**UNITED STATES DISTRICT COURT
NORTHERN DISTRICT OF INDIANA
HAMMOND DIVISION**

UNITED STATES OF AMERICA, <i>et al.</i> ,)	
Plaintiffs,)	
)	
v.)	CAUSE NO.: 2:11-CV-328-JVB-APR
)	
CITY OF ELKHART, INDIANA,)	
Defendant.)

AMENDMENT OF THE CONSENT DECREE

EXHIBIT A

Schematic #1: Block Flow Diagram of WWTP Improvements

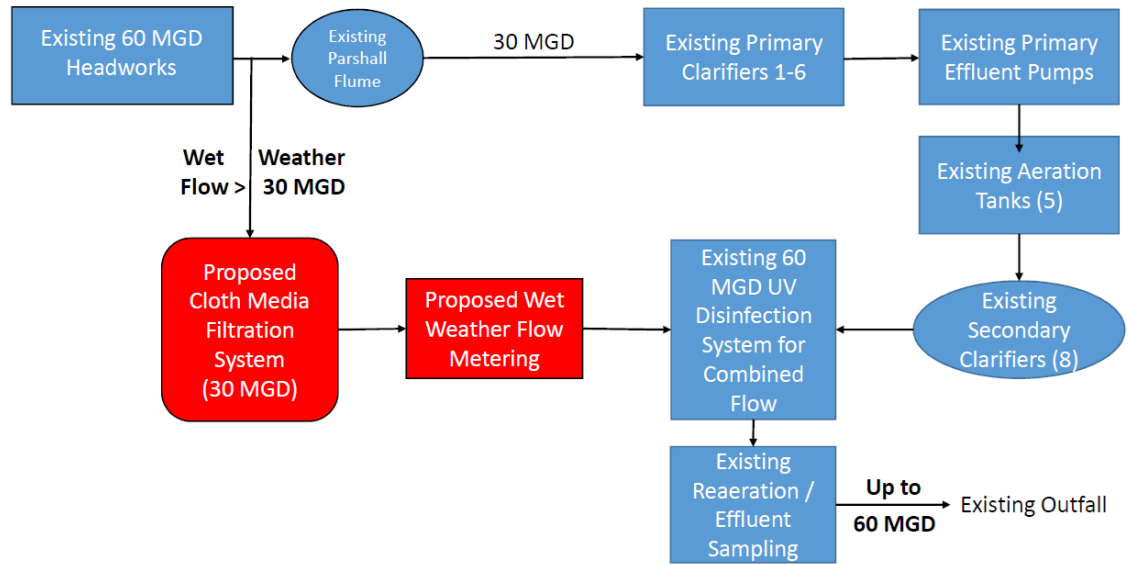
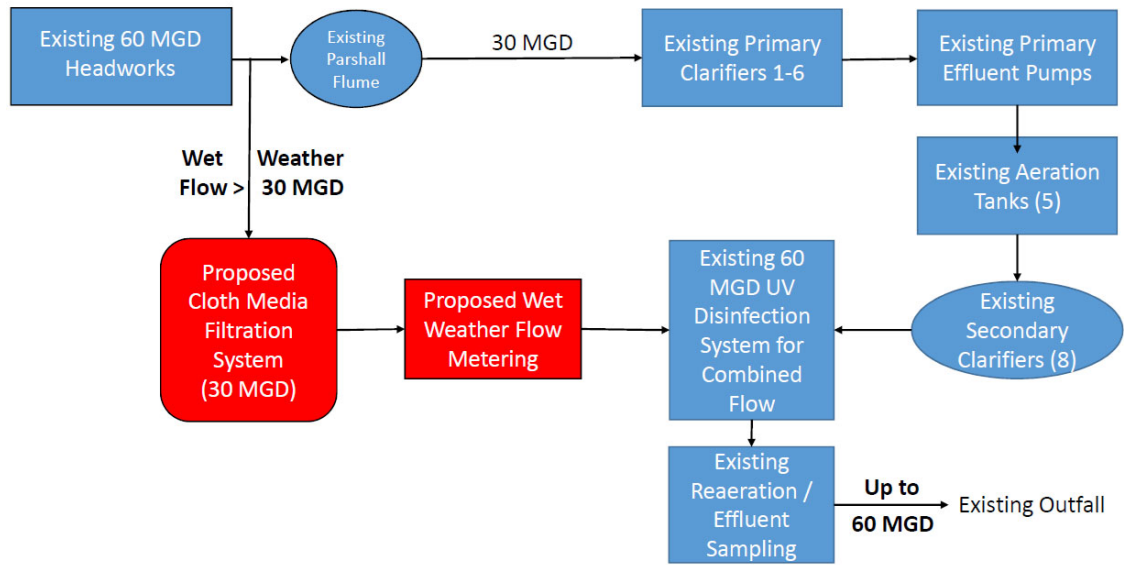
Please refer to the 2 included schematics. Schematic #1 is a block flow diagram of WWTP improvements reflecting, amount other things, the CMDf System and the use of 6 remaining Primary Clarifiers. Schematic #2 is a Flow Sheet showing the CMDf Diversion, CMDf Process, and CMDf Effluent flow measurement prior to combining with WWTP Final Clarifier Effluent for combined UV Disinfection. Not shown on Schematic #2 is CMDf influent and effluent probes, that are planned for both process control trending and coagulant feed control.

Schematic #2: CMDF Process Flow Sheet

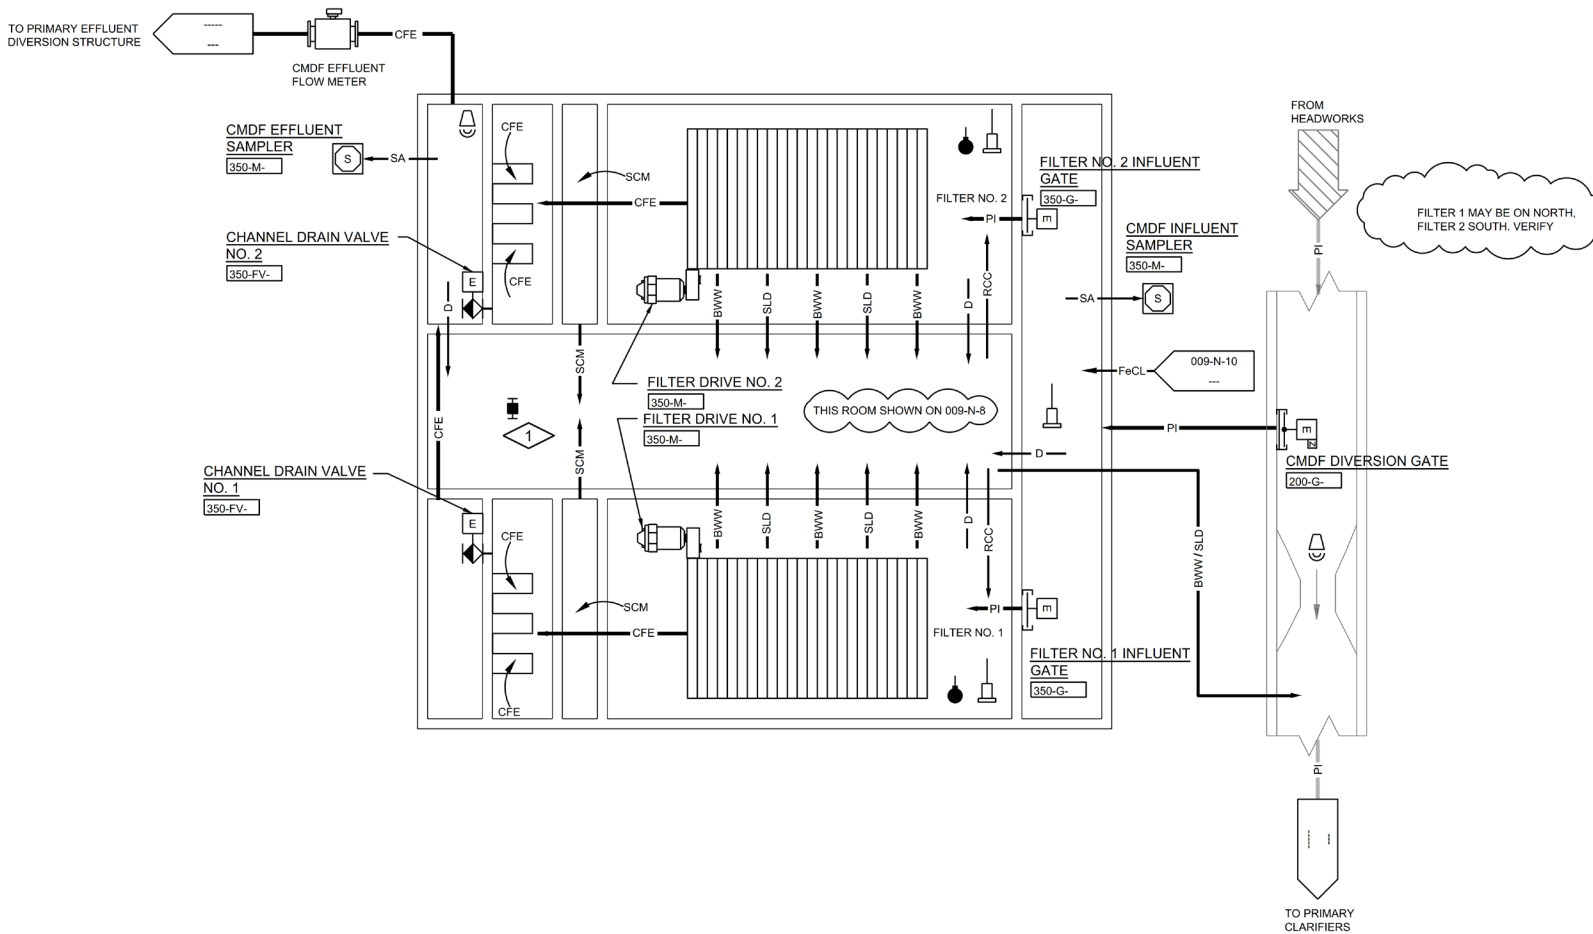
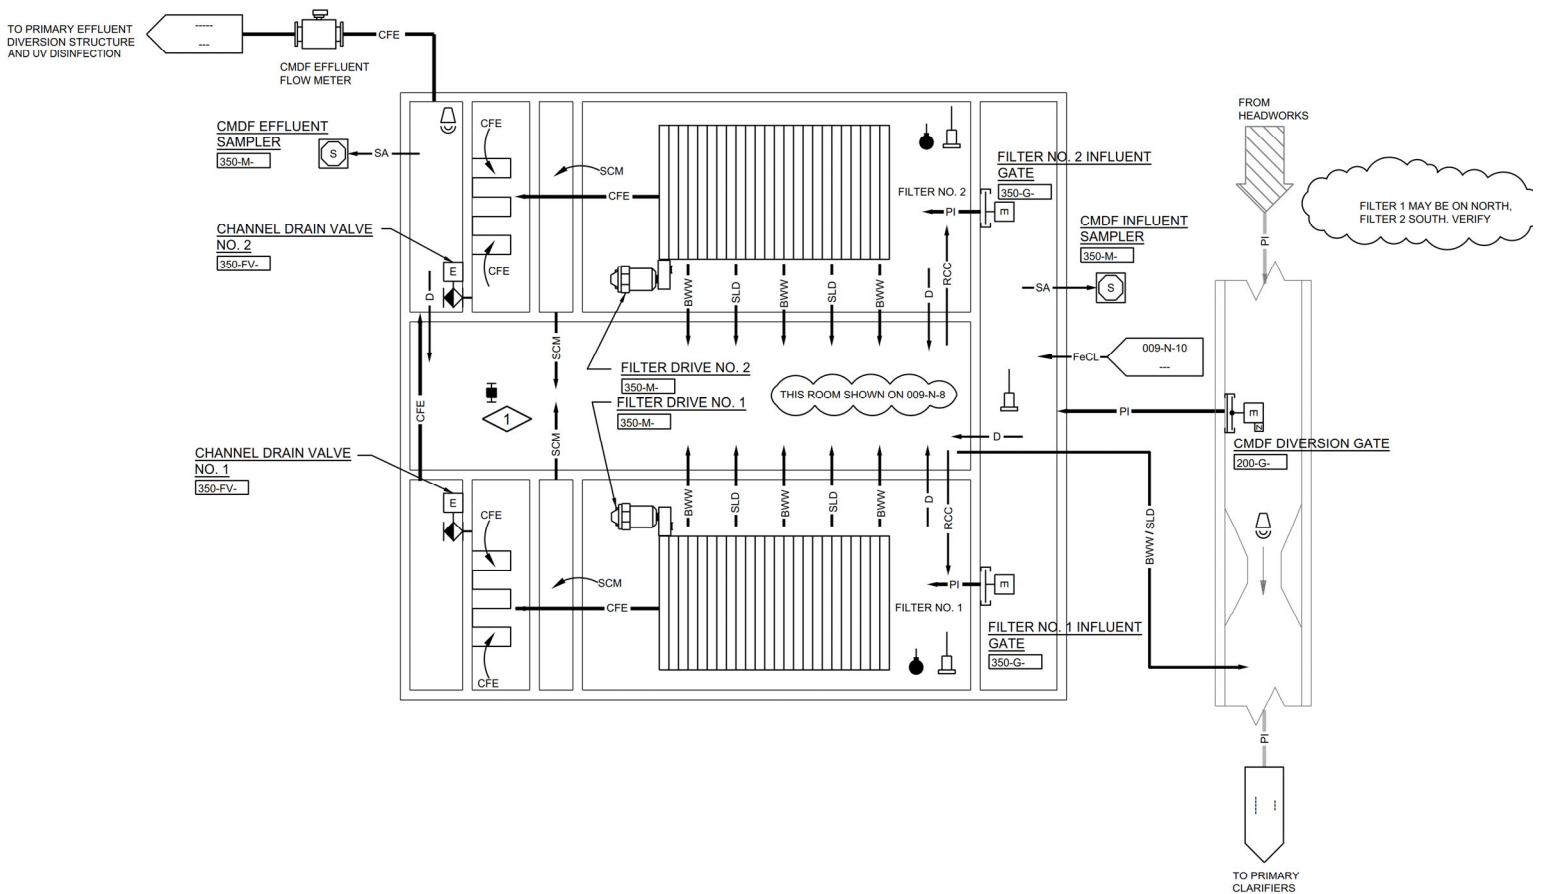
WHEREAS, the following schematic of Appendix A is amended: #2 (label only).
